**CITY HALL AND  
CITY HALL ANNEX  
ACCESSIBILITY SURVEY**

**July, 2007**

**CITY OF SANTA  
BARBARA**

*Public Right-of-Way - Photo # 4*

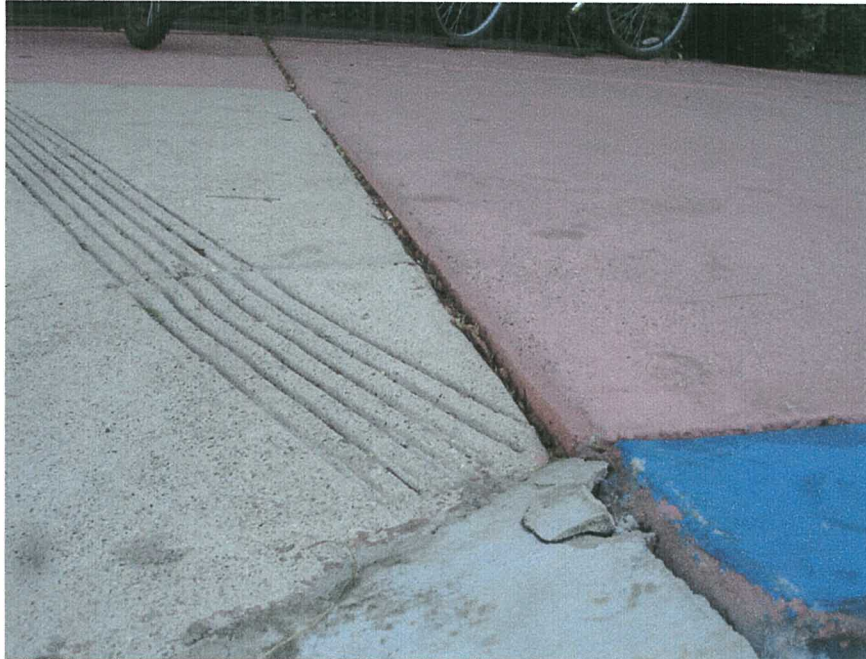
*There are no detectable warnings at the curb ramp to warn blind pedestrians that they are walking into vehicular area. The grooves around the curb ramp are 4" wide instead of the required 12".*

*Public Right-of-Way - Photo # 6*

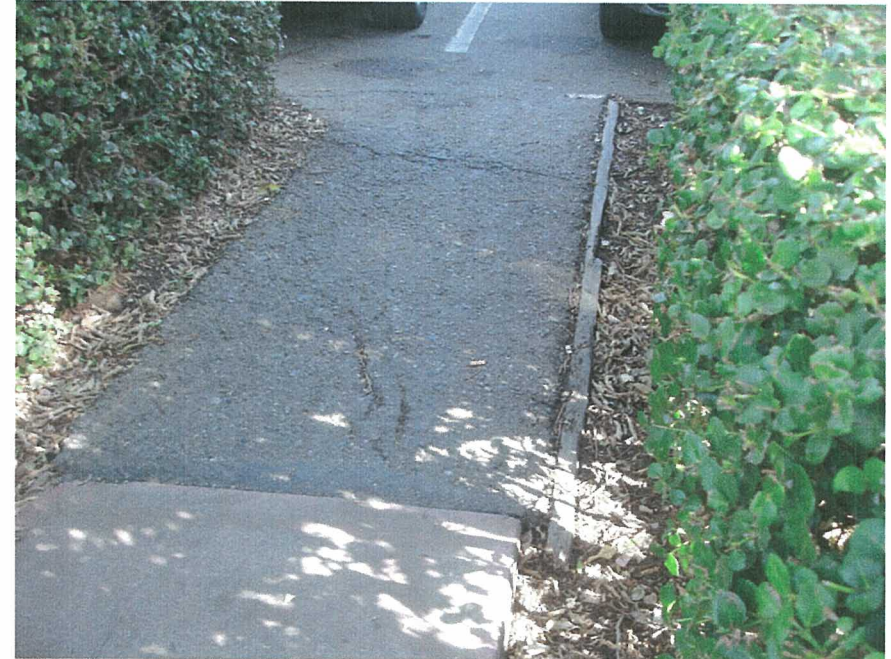
*Broken concrete and vertical drop greater than 1/4" high  
needs to be repaired.*

Site - Photo # 4

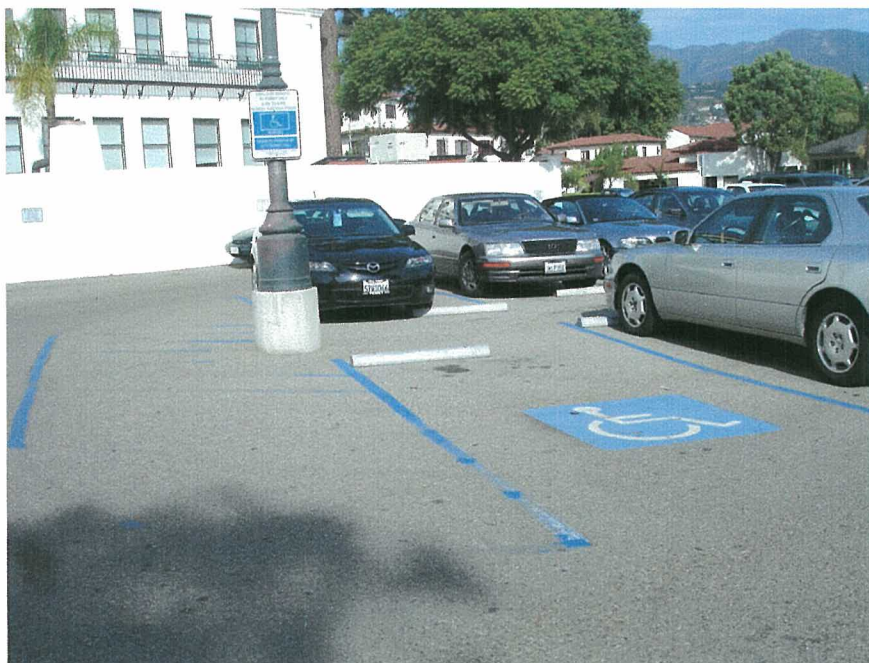
*This combination parking sign and tow-away sign does not have the size or language required by code. Two separate compliant signs needed.*

Tow Away sign at entrance to off-street parking facilities.	Yes (CA only)		Tow away combined with parking sign.  Photo #: 3	ADAAG: N.A.  T24: 1129B.5	Provide "Tow Away" sign(s) at entrance to off-street parking facilities when altering area.	1	JOB	\$325	\$325	2	
"No Parking" painted at access aisle.	Yes		None.  Photo #: 4	ADAAG: N.A.  T24: 1129B.4(1) & (2)	Provide the words "No Parking" at each access aisle, painted in 12" high letters.	1	JOB	\$250	\$250	2

Site - Photo # 5

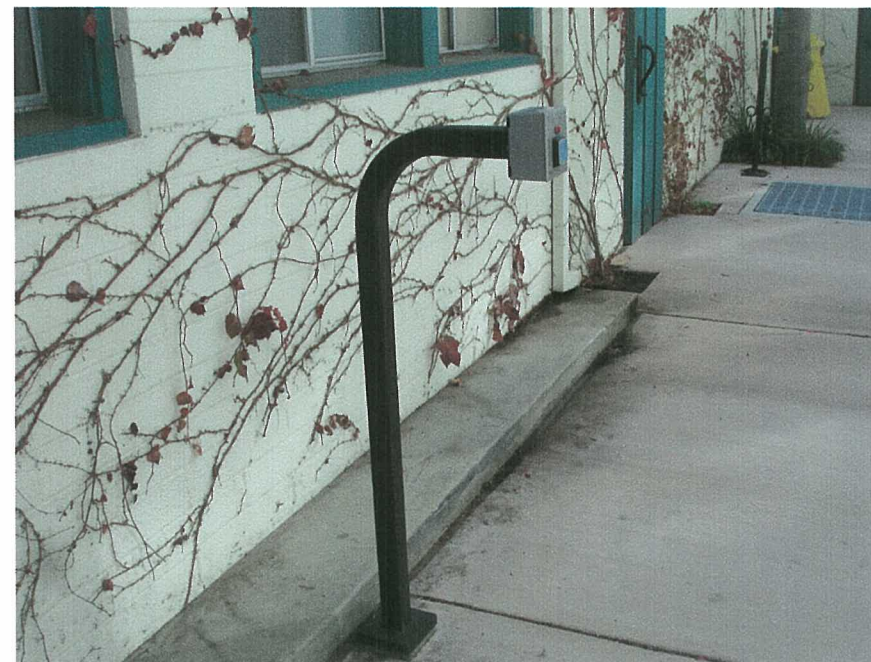
*There is not a "No Parking" sign at the rear of the access aisle. The access aisle is not striped as required by code.*

Site - Photo # 6

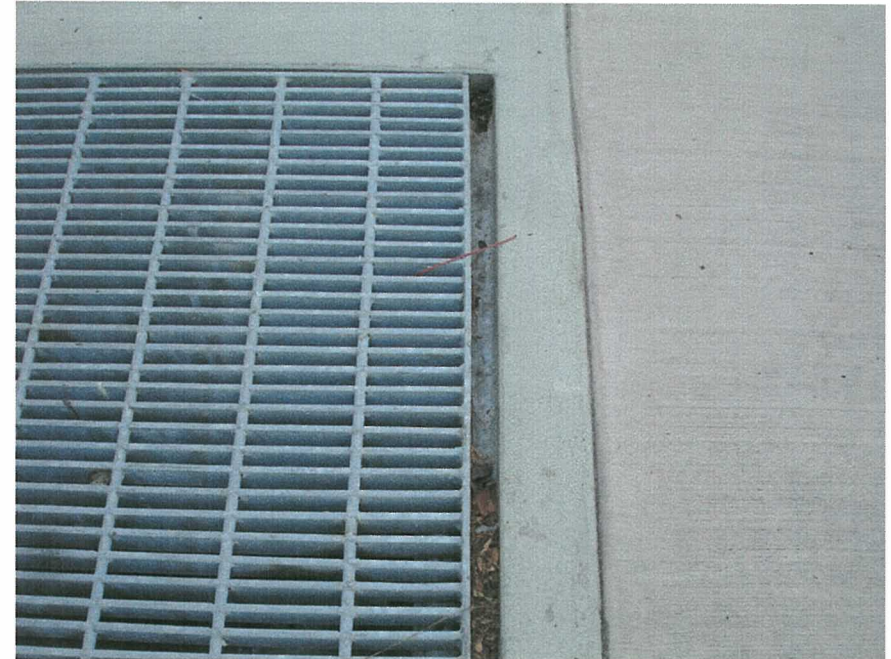
*Path of travel from accessible parking stalls require persons with disabilities to travel through the parking lot, which does not have striped marked crossings. There is not a "No Parking" sign at the rear of the access aisle. The access aisle is not striped as required by code. The sign is not compliant.*

*Building - Photo # 3*

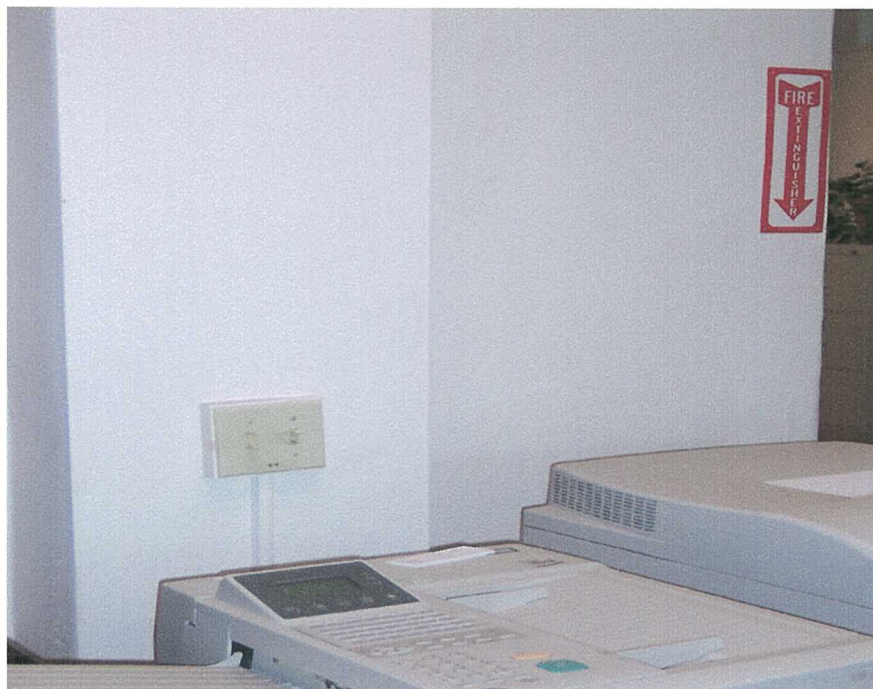
*There is no wheelchair access to storage area. Drop down stairs do not have the required knee clearance, compliant handrails. Stairs have open risers.*

*Building - Photo # 6*

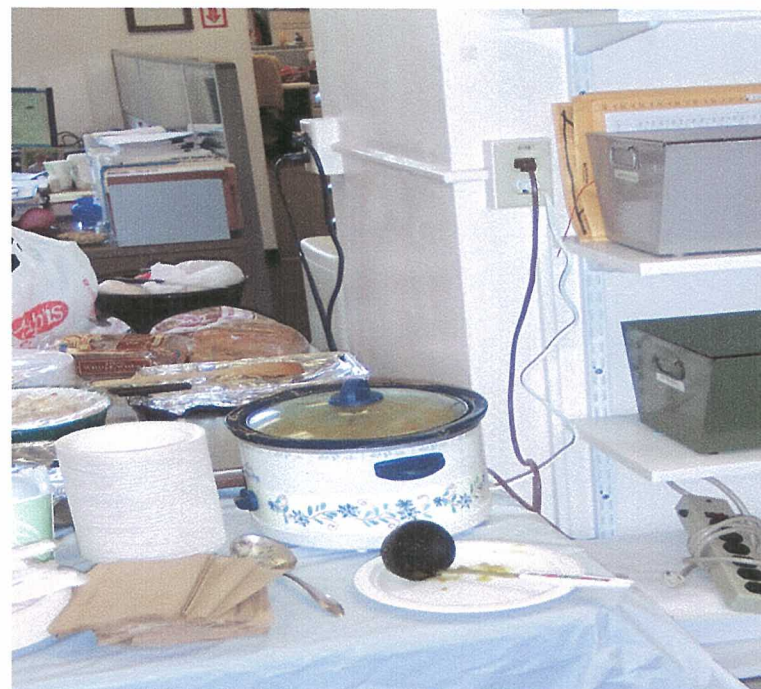
*Light switches are mounted behind copier, not accessible to wheelchair users.*

ITEM/ LOCATION	CONDITION BARRIER	REQUIREMENT	EXISTING CONDITION	CODE REFERENCE	SUGGESTED RECOMMENDATION	QTY	UNIT TYPE	UNIT COST	TOTAL COST	PR	IMPL DATE
Bottom Kick plate-door stop.	10" high min. smooth, uninterrupted surface at push side of doors on accessible route. (CA only). Except for automatic & sliding doors.	Door stop mounted at kick plate area. Photo #: 4	ADAAG:  T24: 1133B.2.6; Fig. 11B-29	Remove door stop when altering area. Provide wall mounted door stop.	1	JOB	\$40	\$40	2		
<b>Electrical, Alarms</b>											
Electric switch or control mounting height, intended to be used by the occupant of the room or area to control lighting and receptacle outlets, appliances, or cooling, heating and ventilating equipment.	The center of the grip of the operating handle of controls or switches 48" high above floor to center line of control.	Switch mounted at 47" high, but located behind copier. Photo #: 5	ADAAG: 4.2.5; 4.2.6  T24: Article 380-8 (c ) C.E.C.Chapter 3	Relocate copier to provide compliant approach to switch.	1	JOB	\$50	\$50	4

*Building - Photo # 12*

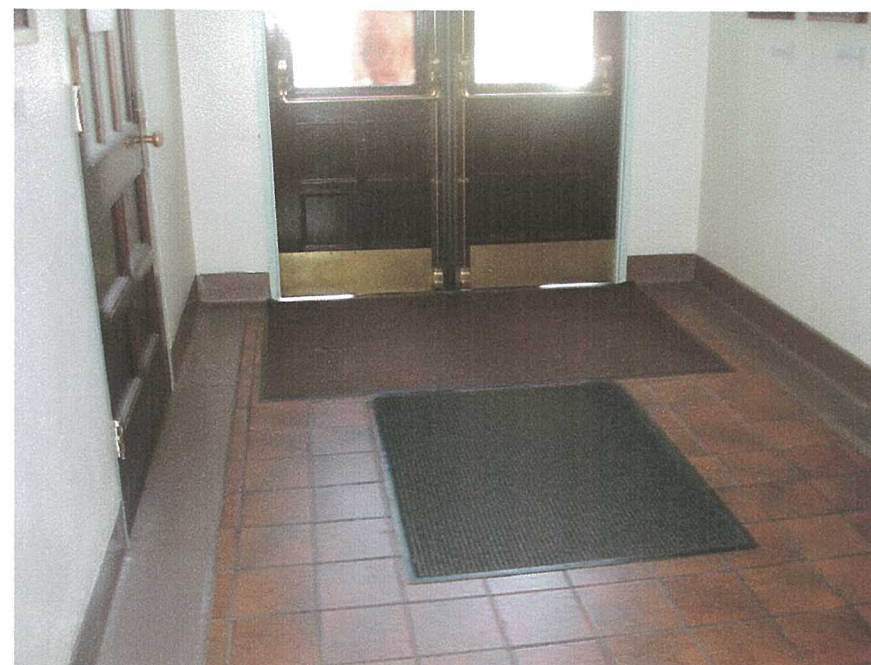
*Ramp handrails are mounted more than 1 ½" from the wall. The ramp surface does not appear to be slip resistant as required by code mainly when wet. The surface is not vibration free.*

Ramp Surface	Ramp surface shall be firm, stable and slip resistant.	Ceramic tile ramp surface is not smooth, vibration free and slip resistant. Photo #: 12	ADAAG: 4.5.1 T24: 1133B.7.1.1	Provide a firm, stable and slip resistance surface.	288	SF	\$34	\$9,792	2	
Ramp Handrails Mounting Height	Handrail mounting height shall be between 34" to 38" high.	Handrail mounted at 32" high. Photo #: 12	ADAAG: 4.9.4 (5) T24: 1133.B.4.2.1	Modify existing handrail as needed to remount between 34" to 38" high.	1	JOB	\$500	\$500	4

*Building - Photo # 17*

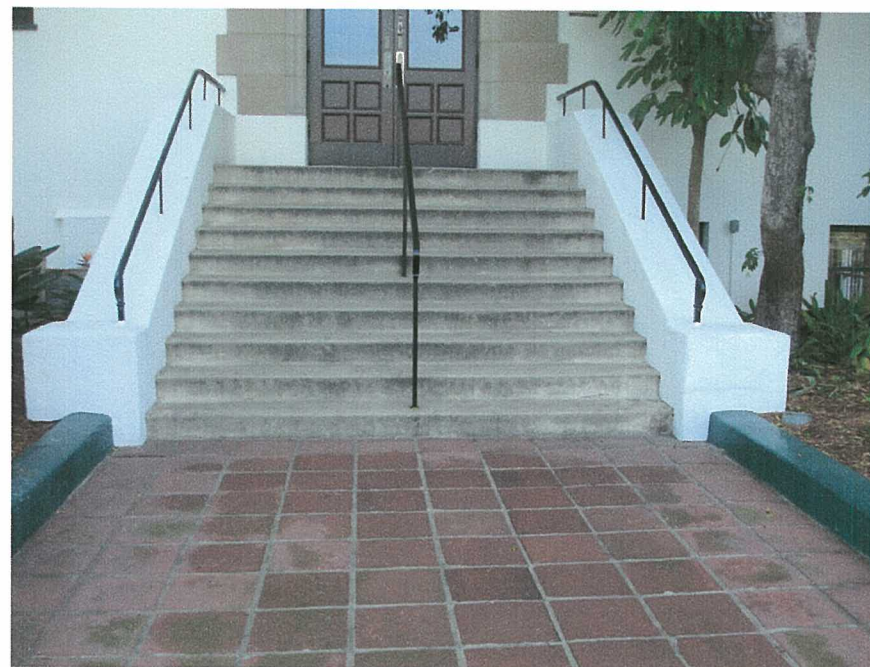
*Threshold too high, panic rod protrudes into the 10" kick plate required to be smooth.*

Bottom Kick plate - panic rod.	10" high min. smooth, uninterrupted surface at push side of doors on accessible route. (CA only). Except for automatic & sliding doors.	Panic rod at kick plate area.  Photo #: 16	ADAAG:  T24: 1133B.2.6; Fig. 11B-29	Provide panic rod kick plate cover on push side of door when altering area.	2	JOB	\$300	\$600	3		
Electrical, Alarms											
Emergency warning systems when facility has a fire alarm system.	Audible and visual signal (strobe lights) required at restrooms, meeting rooms, hallways, lobbies and any other type of common use area.	No strobe light.	ADAAG: 4.1.3(14); 4.28.1 through 3  T24: 1114B.2.4	Provide audible and visual alarm signals connected to the existing fire alarm system.	1	JOB	\$1,200	\$1,200	2

*Building - Photo # 20*

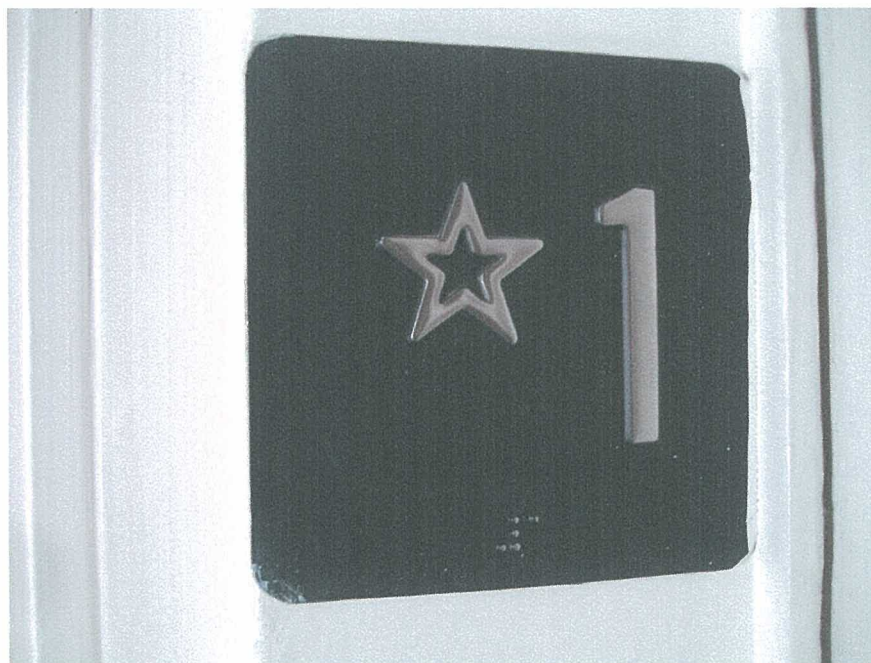
*Elevator does not have the required elevator cab size; hallway call buttons are not fully illuminated. The clear door opening is 30" wide instead of 36" wide. Doorjamb signs have Federal Braille.*

*Building - Photo # 28*

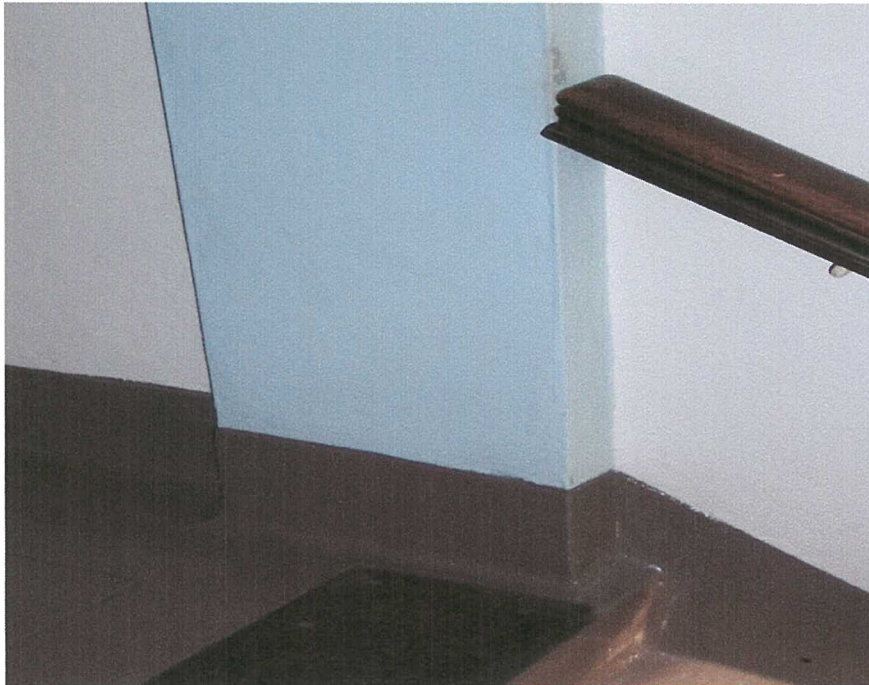
*The handrail is not continuous and it does not have the required 1 ½" diameter, and the required handrail extensions. There is no contrasting color striping.*

*Building - Photo # 31*

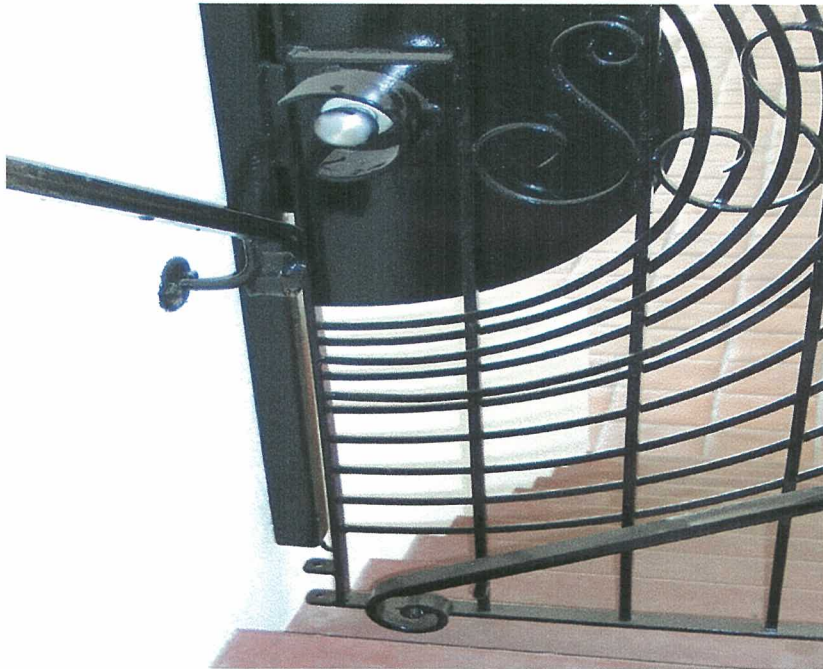
*Stairs do not have contrasting color striping. Handrails do not have the compliant extensions and 1 ½" maximum diameter grip. There is not a compliant landing at the gate location placed in the middle of the stair without compliant hardware.*

*Building - Photo # 3*

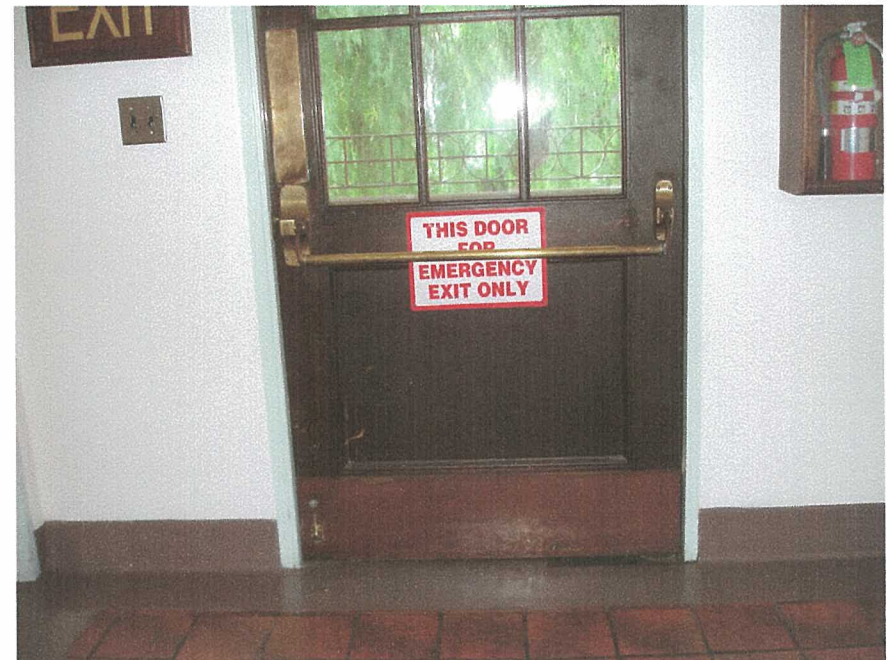
*Fire extinguisher does not have accessible type hardware. It protrudes 7" from the wall into the path of travel; it is mounted above 27" without a cane detectable element – maximum protrusion allowed 4".*

Fire exit signs.		Raised letters & Braille, on wall adjacent to latch side of door, 60" above floor, contrasting color, no obstacles within 3" of sign.	No fire "EXIT ROUTE" sign provided. Photo #: 3	ADAAG: 4.1.2(7); 4.30.4 & 4.40.5 T24: 1117B.5.3; 1117B.5.4	Provide tactile and Braille fire exit signage.	1	JOB	\$120	\$120	2	
------------------	--	---	---	---	--	---	-----	-------	-------	---	--

*Building - Photo # 10*

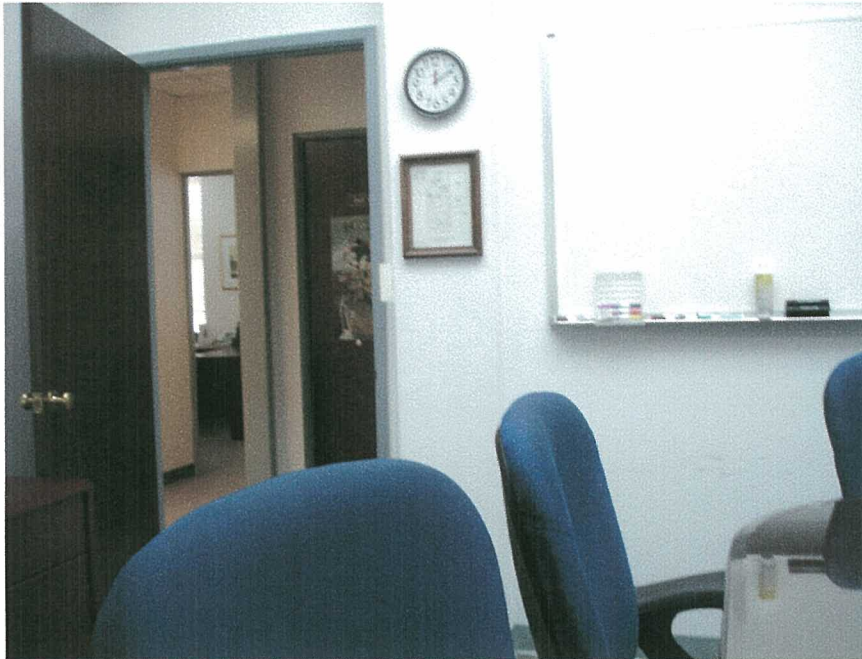
*Doorknob requires tight grasping to operate. There is not the required tactile and Braille room identification sign. Narrow door has a 29" wide clear opening. There is only 2" strike side at the pull side of door.*

*Building - Photo # 12*

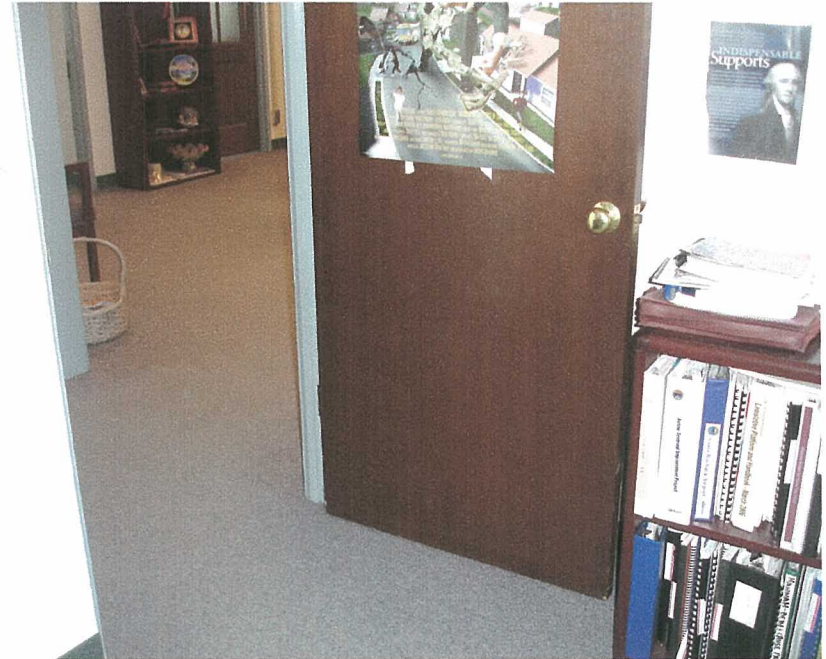
*Doorknob requires tight grasping to operate.  
Marker board is mounted too high at 43" high.*
